Written Representation

A47 / A11 Thickthorn Junction – submitted Development
Consent Order Application

Identification No. TR010037

Evidence by David Cumming
Strategic Transport Team Manager

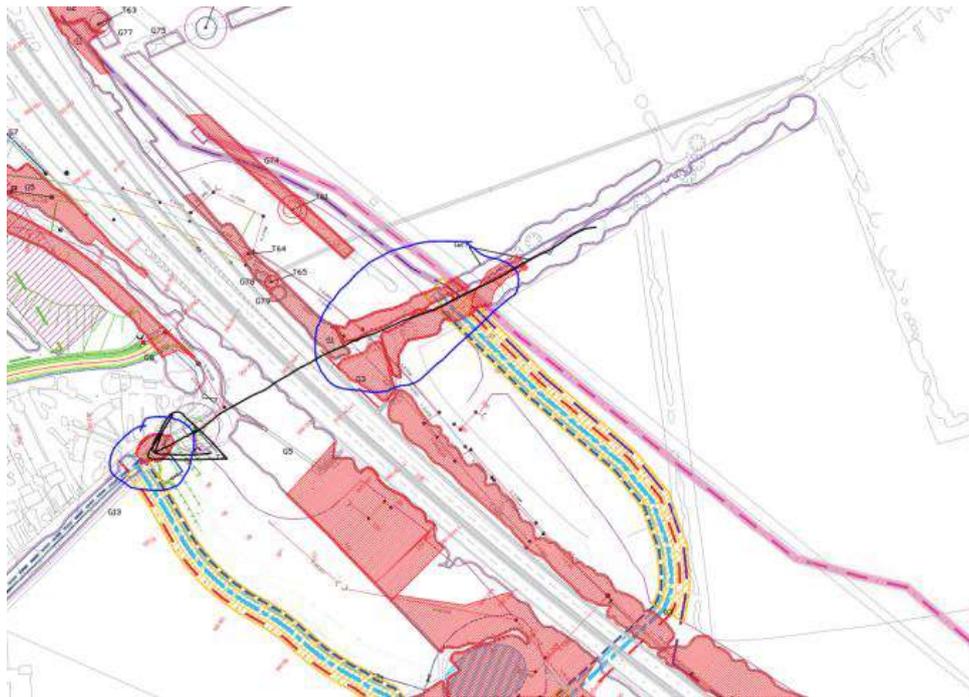
Para 8.4.15 refers to the DEFRA Biodiversity Metric 2.0. The calculations should be available for examination. Table 8-11 (page 51) 'Habitat types and areas to be remediated or enhanced' provides an indication but does the proposed development result in an overall biodiversity net gain of and if so, to what extent?

Areas where enhancements are to be secured are not shown on any of the plans. Land identified for mitigation and enhancements should consider future housing allocation sites eg the Greater Norwich Local Plan.

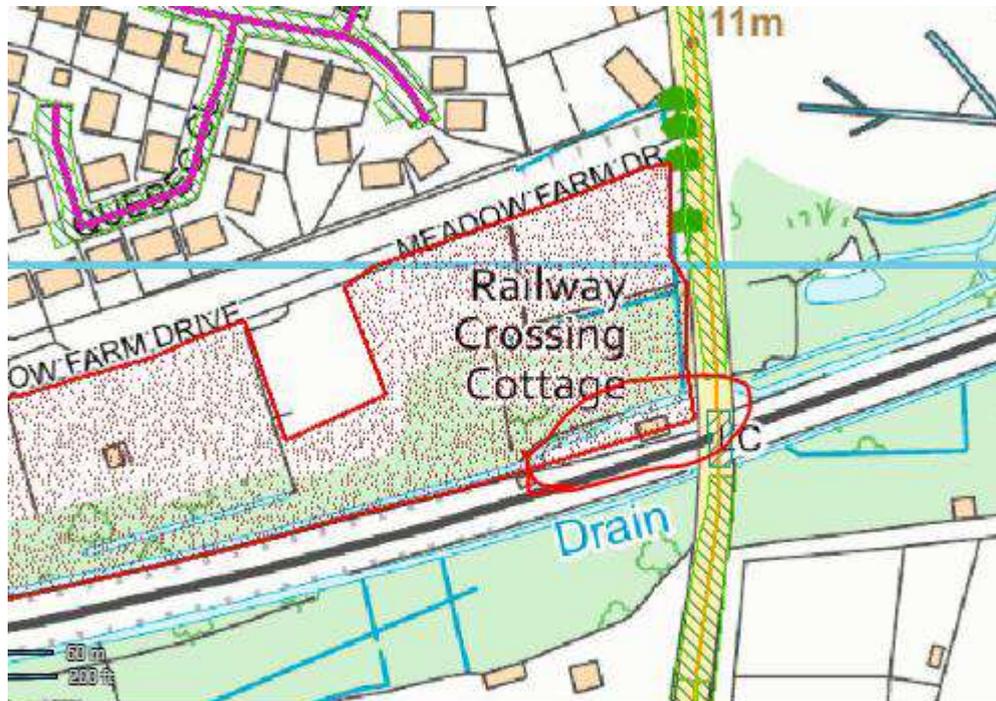
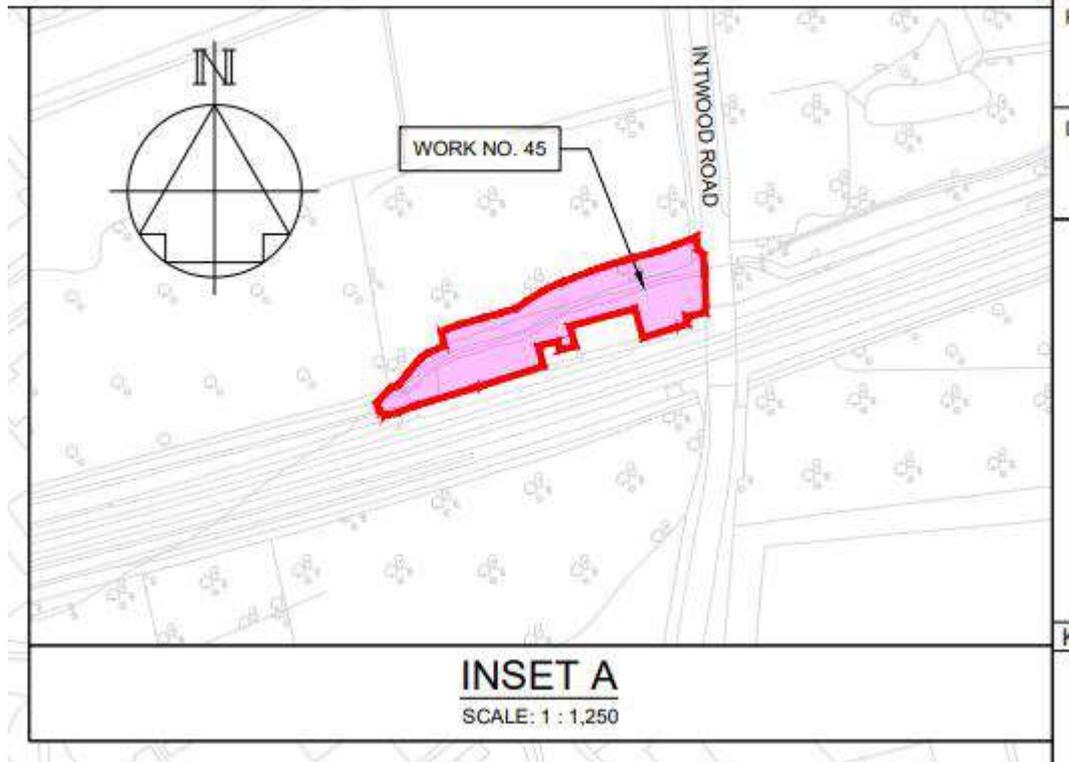
- As alluded to within the bat report, Cantley Lane is an important commuting and foraging corridor for bats. Surveys undertaken in support of 2017/2120 9south Norfolk Council) show that it is of high value to bats (see below). See below: (taken from 2020/0499).

- The loss of substantial areas of vegetation on both sides of the A47, along the line of Cantley Lane, as well as that along the A47 to the south, shown on drawing no. 1050831-SWETHI-AIAP (in the Arboricultural Impact Assessment), will likely result in the loss of this commuting route across the road (a circa 170m gap), and/or increased risk of collision (no evidence has been provided to suggest that the proposed mitigation will be effective. Vegetation also provides bats with shelter from wind and protection from predators. The vegetation also provides a buffer for road noise and head lights.

WORK ORDER 45

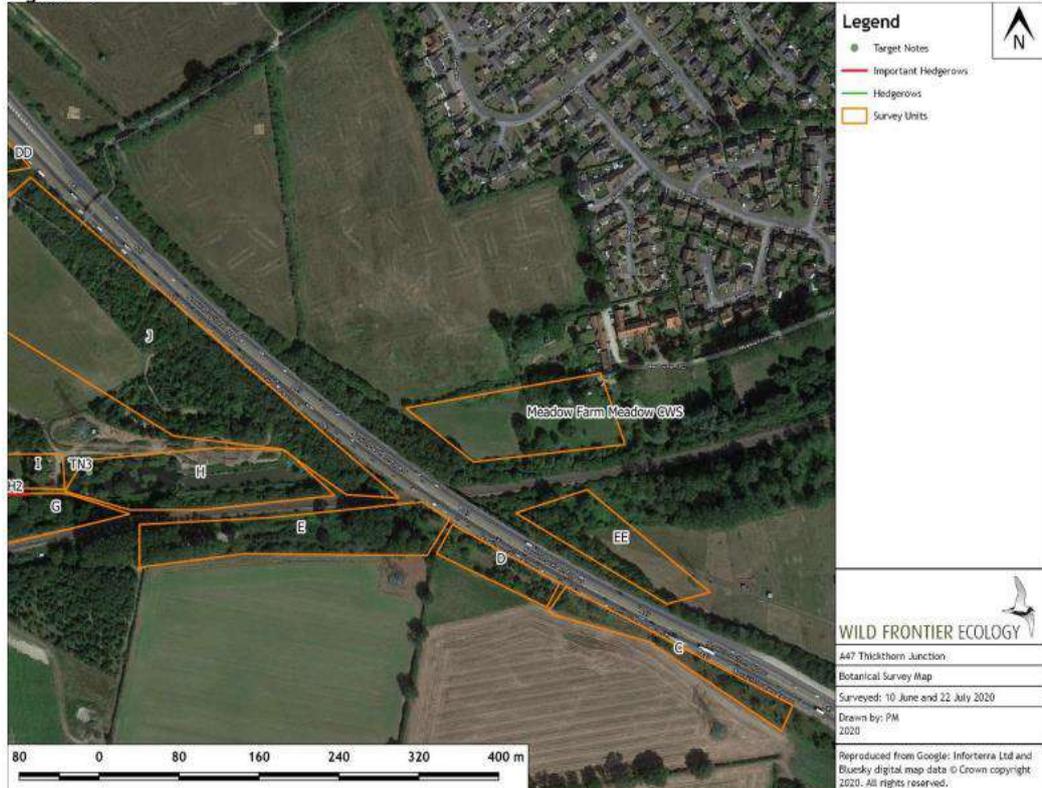
- Work No. 45 (environmental mitigation) is located within Meadow Farm CWS (see below) but this does not appear to have been identified by the applicant. It is not clear what works are planned in this area.

- Work Nos. 6 and 40 may also impact Meadow Farm CWS. Work No 49 abuts Meadow Farm CWS. Work No. 42 directly impacts Meadow Farm CWS and is associated within utilities diversion – it is not clear if this is associated with the UKPN cable route.
- Meadow Farm CWS is only shown to the right of the A47 (top, below). However, it extends to the left of the A47 as shown (bottom, below). This will affect the impact assessment and mitigation requirements.

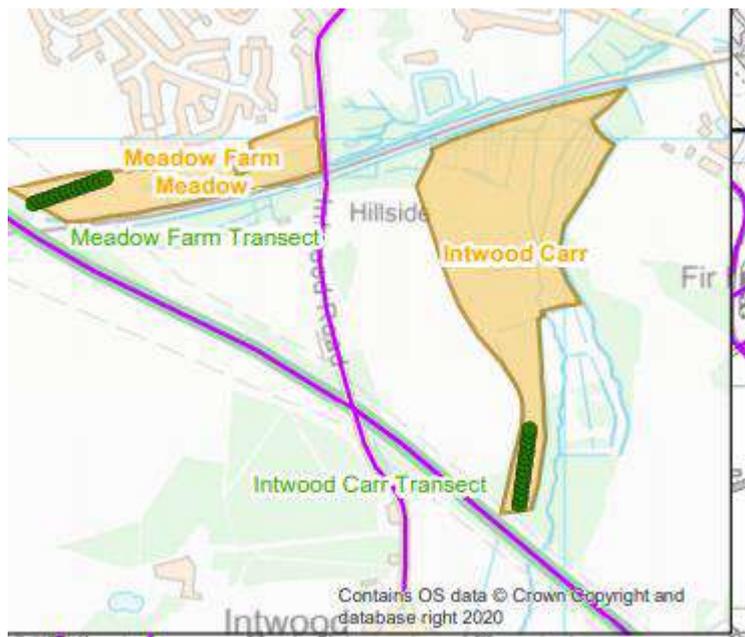
- Para 3.4.8 (below) - It is not clear why reference has been made to Bechstein bats as this species is not present in Norfolk. We (the Natural Environment Team) were consulted in January 2021 with regards to the Long List. During this consultation we queried the use of a 2km CEA ZOI, suggesting the Core Sustenance Zones of bats is used. No mention was made to Bechstein bats.

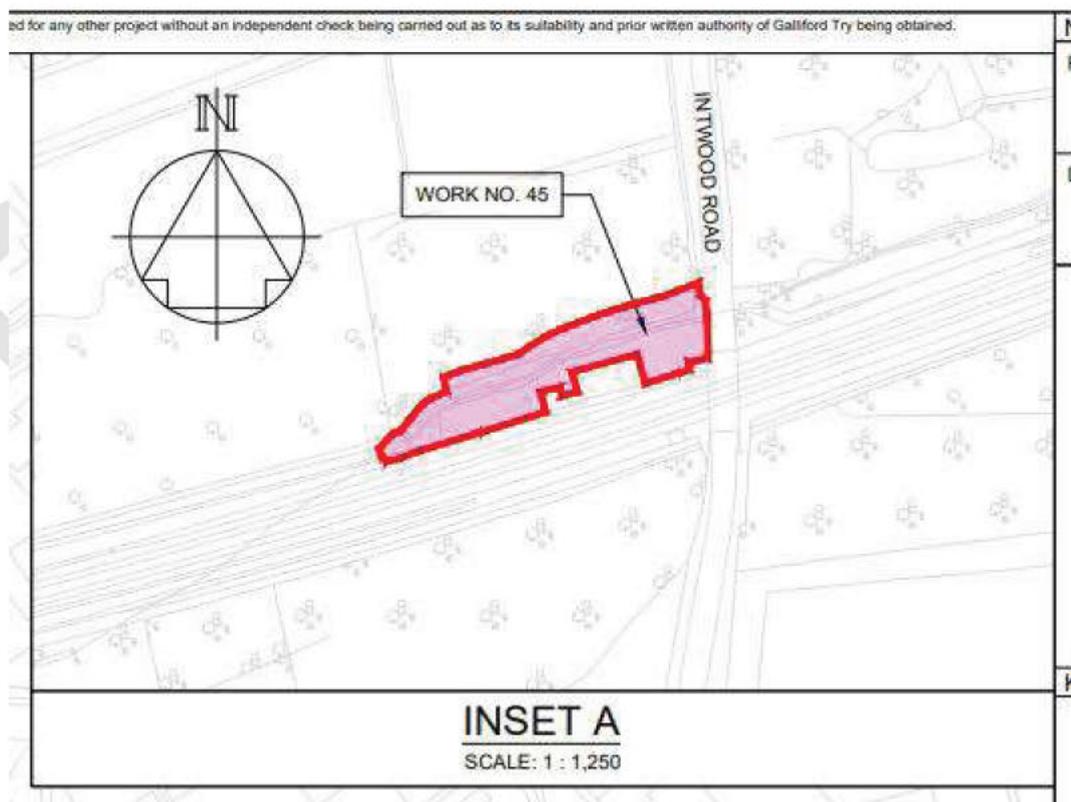
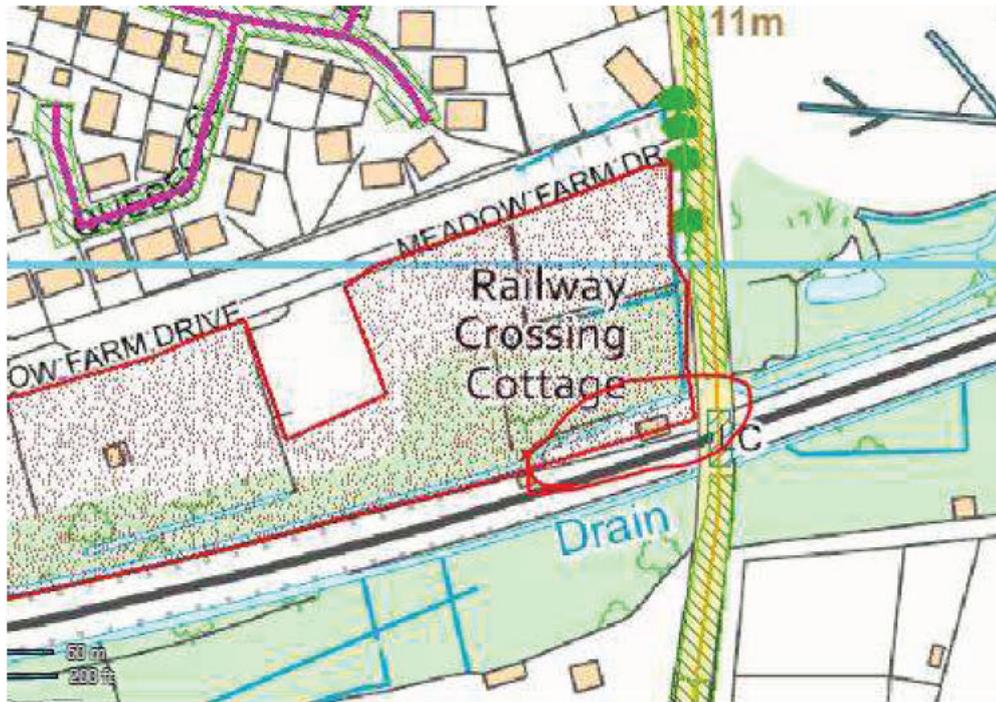
Volume 6 6.2 Environmental Statement Figures 5.5 – 5.8:

- It is not clear what the 'ecological transects' (see below) relate too – for example they do not represent transects undertaken for breeding bird, or bat surveys.

WORK ORDER 45

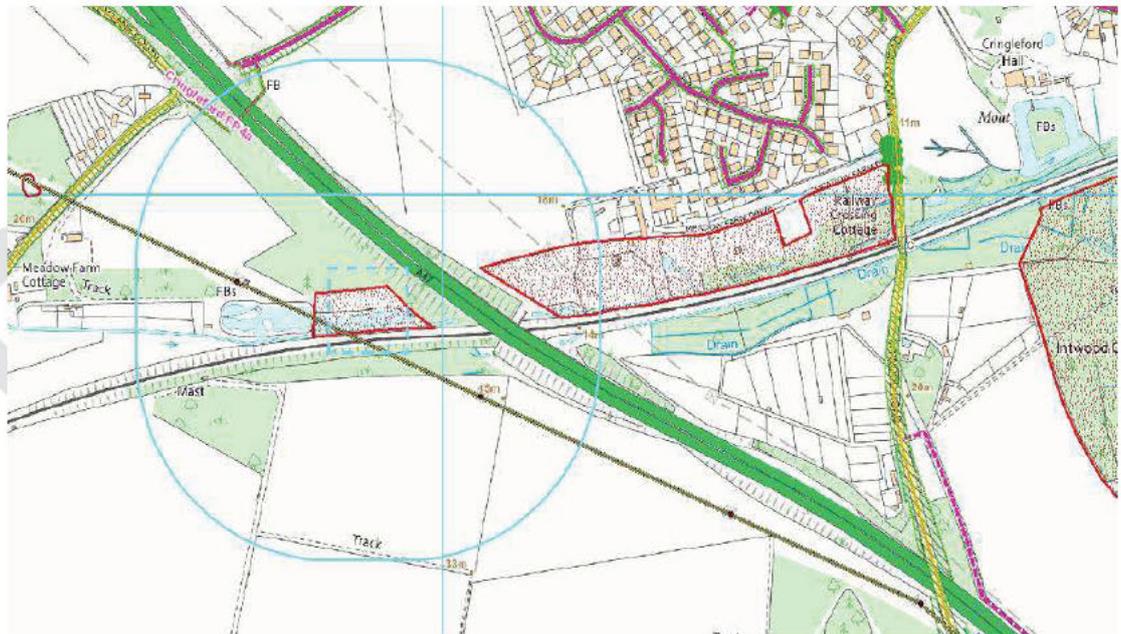
- Work Nos. 6 and 40 may also impact Meadow Farm CWS. Work No 49 abuts Meadow Farm CWS. Work No. 42 directly impacts Meadow Farm CWS and is associated within utilities diversion – it is not clear if this is associated with the UKPN cable route.
- Meadow Farm CWS is only shown to the right of the A47 (top, below). However, it extends to the left of the A47 as shown (bottom, below). This will affect the impact assessment and mitigation requirements.

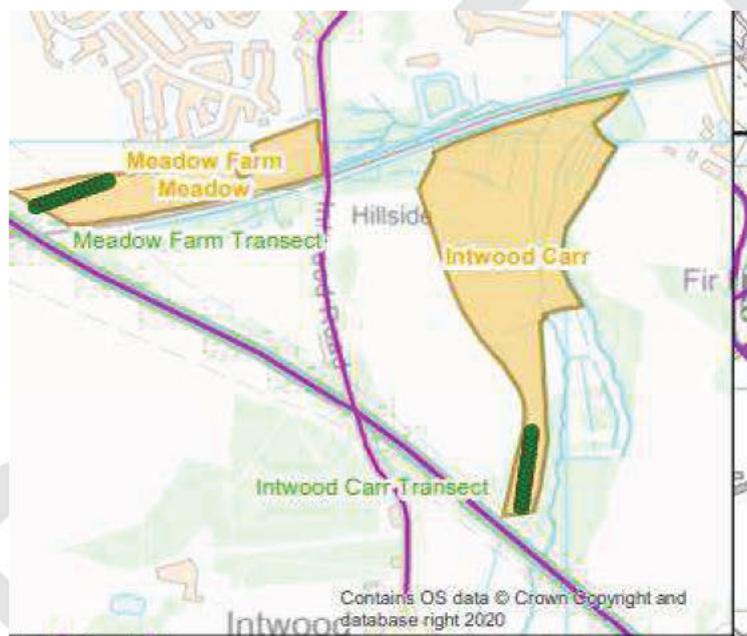
- Para 3.4.8 (below) - It is not clear why reference has been made to Bechstein bats as this species is not present in Norfolk. We (the Natural

Environment Team) were consulted in January 2021 with regards to the Long List. During this consultation we queried the use of a 2km CEA ZOI, suggesting the Core Sustenance Zones of bats is used. No mention was made to Bechstein bats.
